May 1, 2015
File No. 89220
Via Email and U.S. Mail

Town of Carlisle, Zoning Board of Appeals
ATTN. Steve Hinton
66 Westford Street
Carlisle, MA 01741
shinton@mindspring.com

**Re: Phase 2 Report
Independent Hydrogeologic Study
100 Long Ridge Road, Carlisle, MA**

OVERBURDEN GROUNDWATER
POTENTIOMETRIC SURFACE MAP
100 LONG RIDGE ROAD
CARLISLE, MASSACHUSETTS

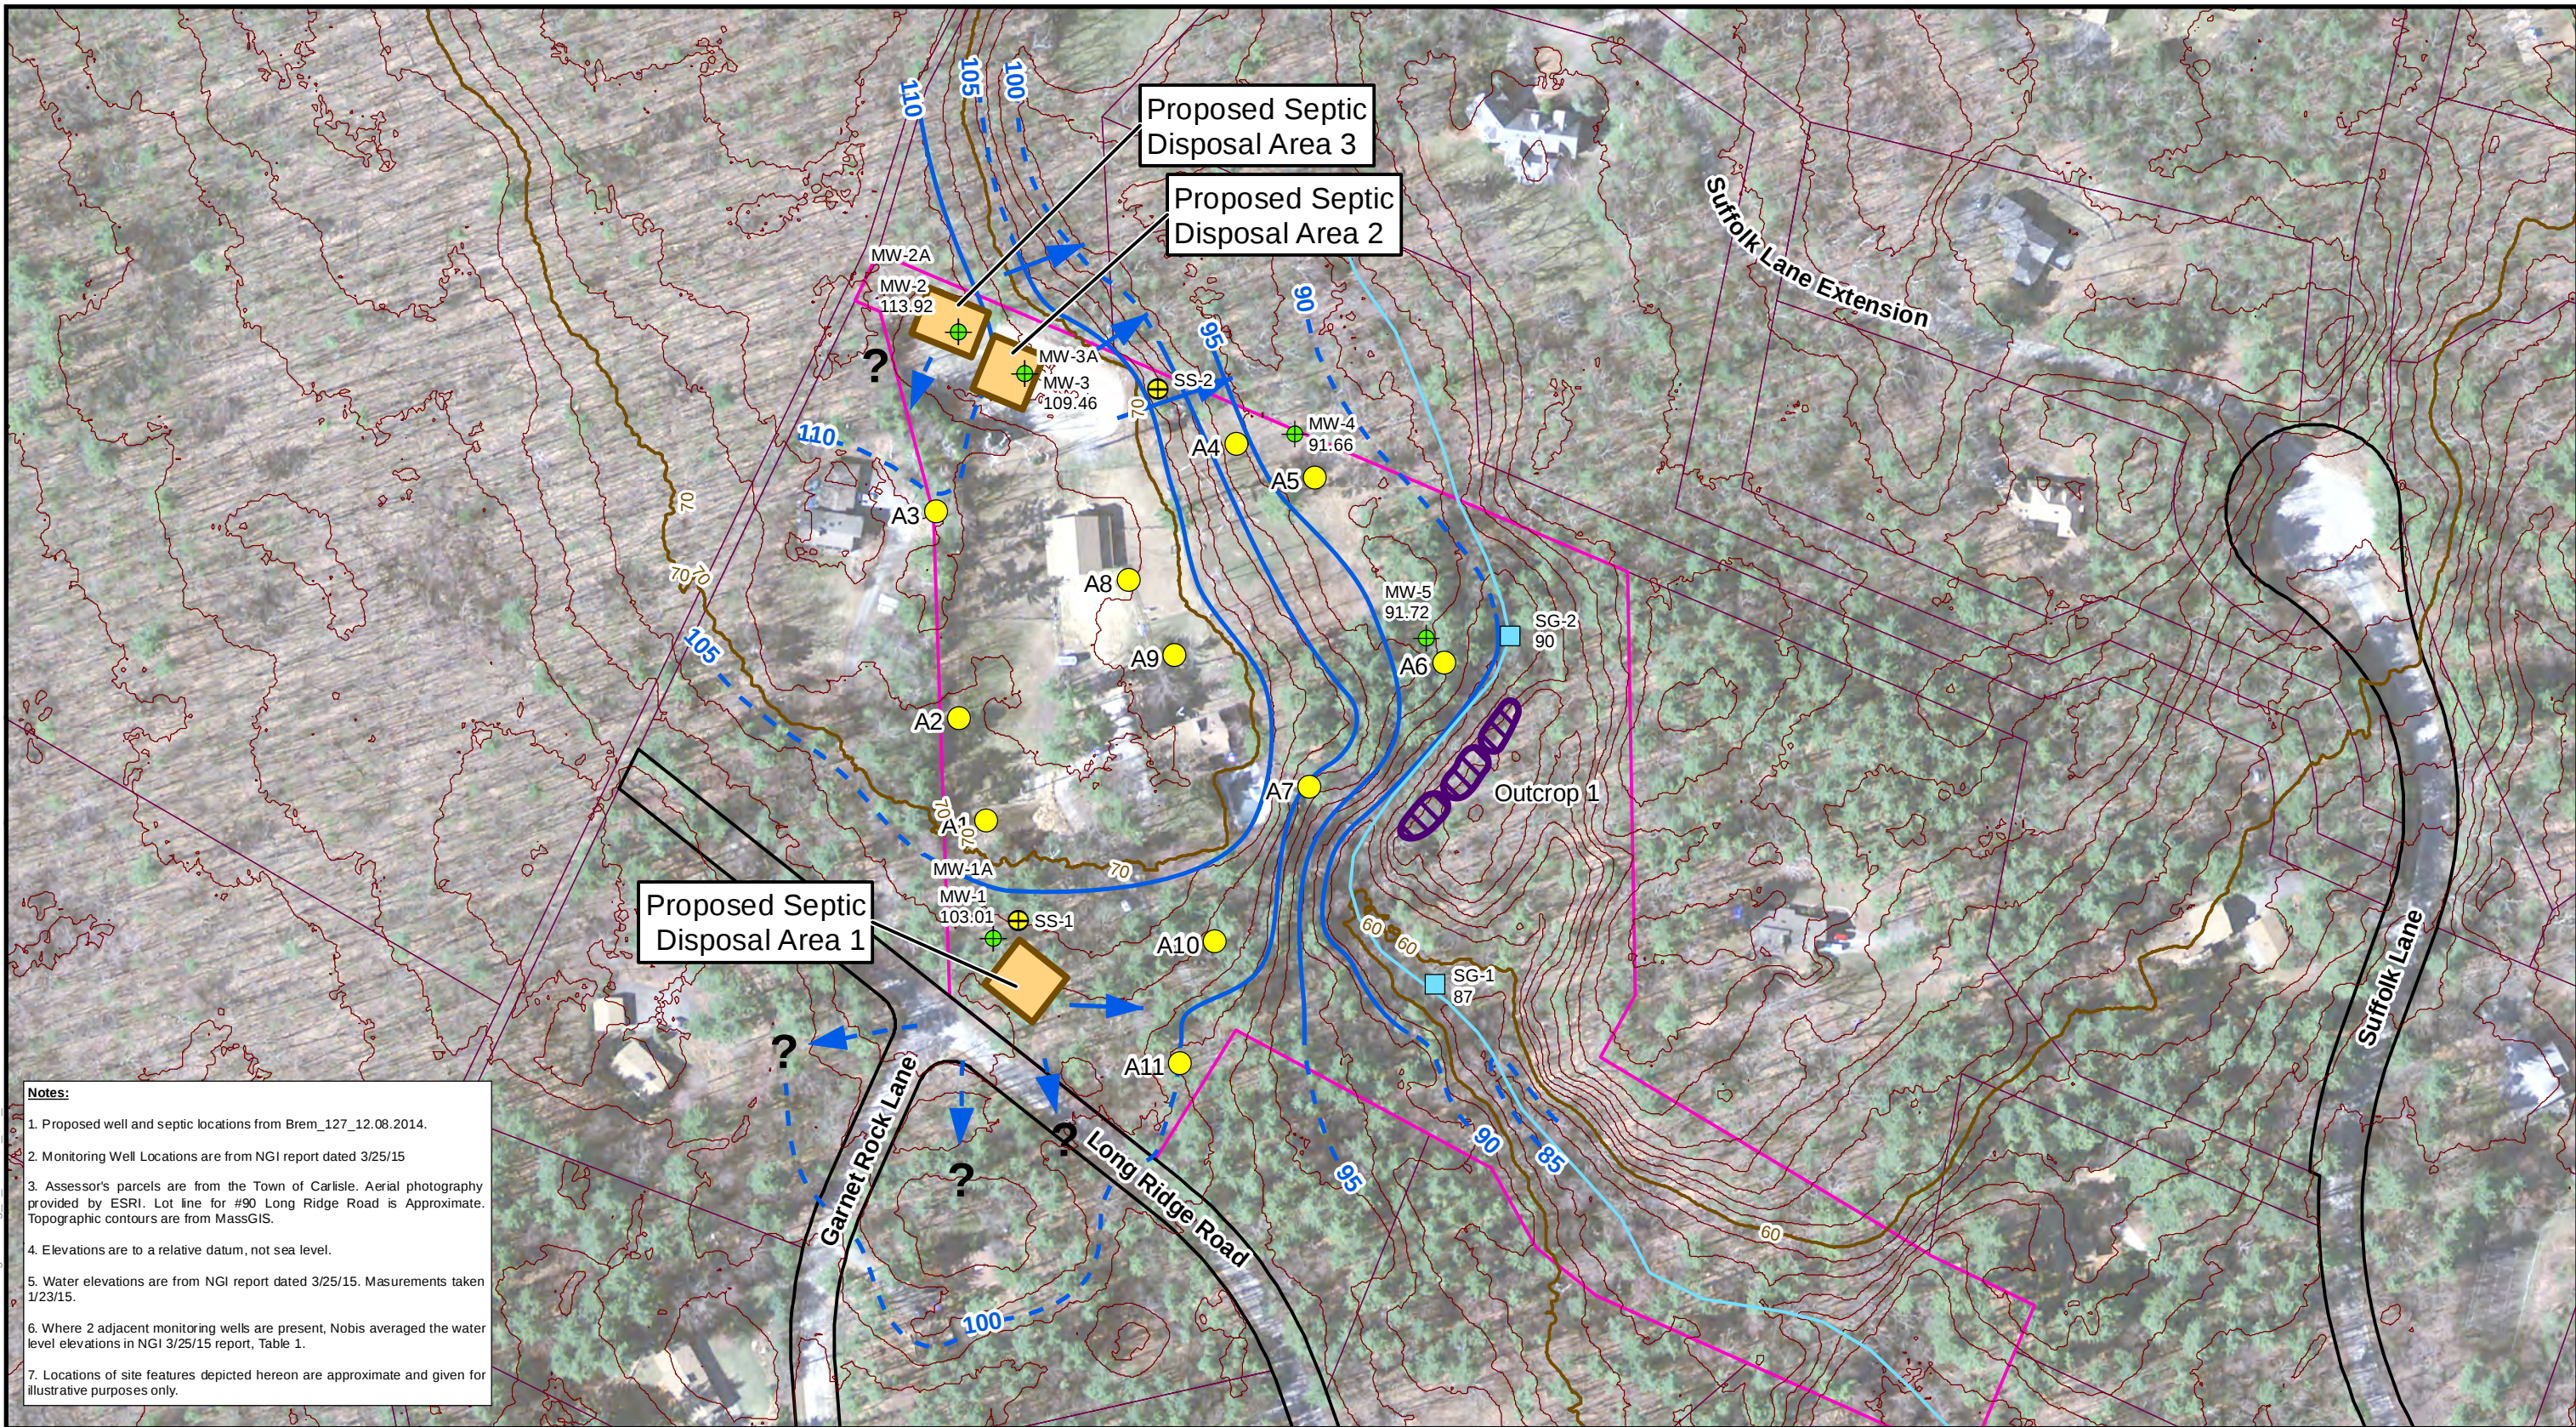
Nobis' interpreted overburden groundwater potentiometric surface contours, based on NGI's measurements, as described above, are shown in Figure 1. Between and beyond the seven locations with water elevation data, Nobis assumed that the potentiometric surface parallels topography; this is a standard assumption in unconfined conditions for a shallow water table in areas where there are no direct water level measurements. The contours are dashed where they are estimated in areas beyond data points.

In a porous medium such as the soil and sandy glacial till that underlies the Site, groundwater flows from areas with higher head to areas of lower head. Flow lines are perpendicular to potentiometric surface contours. In the vicinity of proposed Septic Area 1, groundwater flow can be expected in the easterly or southeasterly directions, based on the groundwater contours shown on Figure 1. However, based on topography, a component of groundwater flow may occur to the south and southwest as well. These flow arrows are shown with question marks on Figure 1. Installation of a new monitoring well or wells in this area would be needed in order to characterize shallow groundwater flow in these directions more accurately. In the vicinity of proposed Septic Disposal Areas 2 and 3, the inferred groundwater flow direction is east-northeast or northeast. Because no water elevation data point (monitoring well) is located in this direction, this groundwater flow direction is somewhat uncertain, but is the most likely, based on the available measurements combined with topography. Installation of a new monitoring well or wells in this area would be needed in order to verify or discount shallow groundwater flow in these directions.

The groundwater potentiometric surface, as interpreted by the contours and groundwater flow arrows in Figure 1, represents current conditions. After construction and when the septic system is in operation, groundwater mounding is expected at the proposed septic disposal areas, locally changing the groundwater contours, groundwater flow gradient, and possibly local flow directions. Anticipated groundwater mounding is described in Section 2.2, and resulting potentiometric surface contours are shown in Figure 2. Neither Figure 1 nor Figure 2 shows the effects that well pumping may have on the overburden potentiometric surface.

OVERBURDEN GROUNDWATER
POTENTIOMETRIC SURFACE MAP
WITH PREDICTED MOUNDING
100 LONG RIDGE ROAD
CARLISLE, MASSACHUSETTS

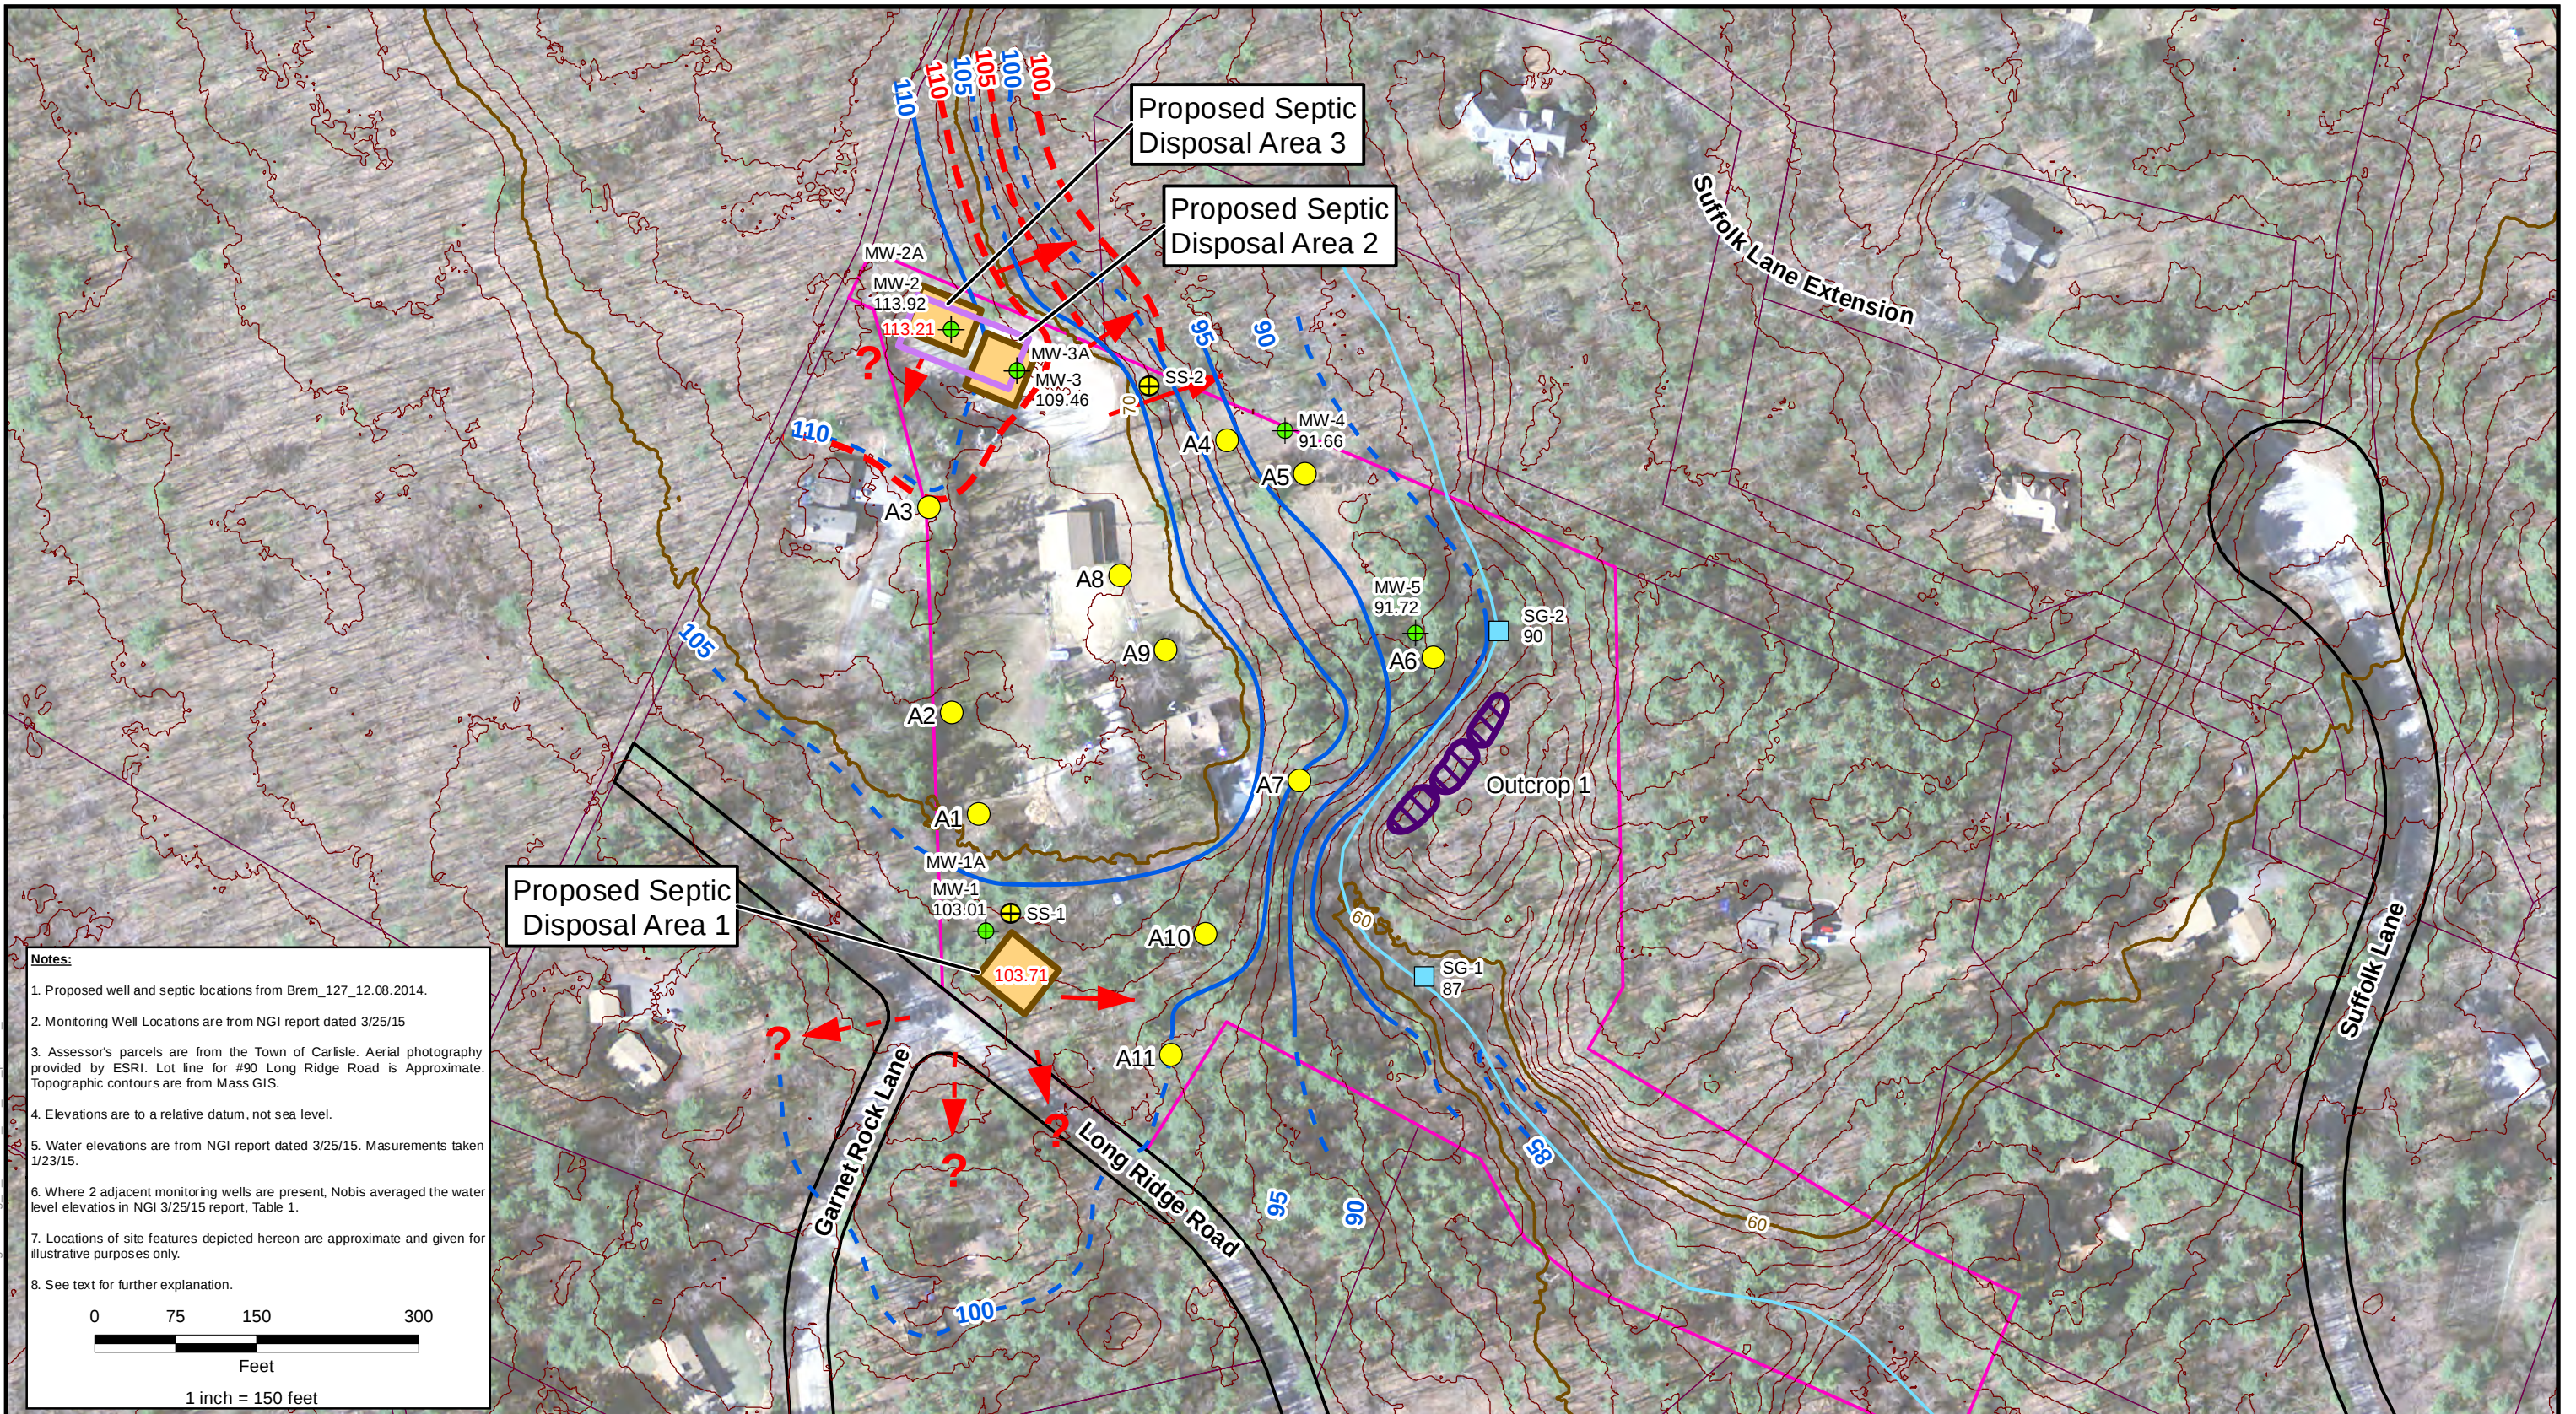
At Proposed Septic Disposal Areas 2 and 3 the predicted mound height of 1.53 feet may cause a noticeable change, at map scale, in groundwater contouring in the vicinity, as shown by red contour lines in Figure 2. These lines are dashed, because they are conceptual and not supported by direct groundwater modeling that extends outside of the Septic Disposal Areas. As with Proposed Septic Disposal Area 1, increased groundwater gradients and groundwater flow velocities can be expected to result from the mound over Areas 2/3. Also, localized flow to the southwest appears likely, in addition to flow to the east-northeast and northeast. Additional monitoring wells would be needed in these areas to verify (or refute) these potential groundwater flow directions.
